APPENDIX K Preliminary Drainage Report

#### PRELIMINARY DRAINAGE REPORT FOR KAHANA SUNSET CONDOMINIUM

COMMENTS FROM THE COUNTY OF MAUI DEPARTMENT OF PLANNING (DEPARTMENT) ON THE DRAFT ENVIRONMENTAL ASSESSMENT (EA) PREPARED IN SUPPORT OF THE PROPOSED KAHANA SUNSET AOAO SHORELINE AND SITE IMPROVEMENTS, AT 4909 LOWER HONOAPIILANI ROAD, LAHAINA, MAUI, HAWAII; TMK: (2) 4-3-003:015 (CPA 2012/0003) (CIZ 2012/0007) (SM1 2012/0003) (SSV 2012/0002) (EA 2012/0002)

Fig. 1 Existing Storm Drain System at Kahana Sunset

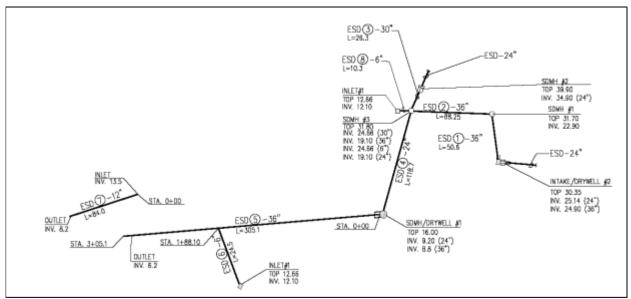
**Drainline.** The existing approximately 300-foot long 36-inch corrugated metal drainline, identified as Existing Storm Drainline (ESD) No. 5, running from a drywell at the top of the courtyard to the existing seawall near Building "A" is proposed to be replaced due to its age (See: Figure No. 11). The outlet at the seawall may be shifted approximately 5 feet north, towards Building "A" and approximately 3 feet to the east (landward). Other drainage improvements include:

- Upsize ESD No. 6 (approximately 70 feet) and Inlet No. 1.
- Replace Open Channel No. 2 with an inlet and subsurface drainline to ESD No.
- Retrofit and install filters on Inlet Nos. 1 & 2 to capture sediments, debris, and other pollutants.
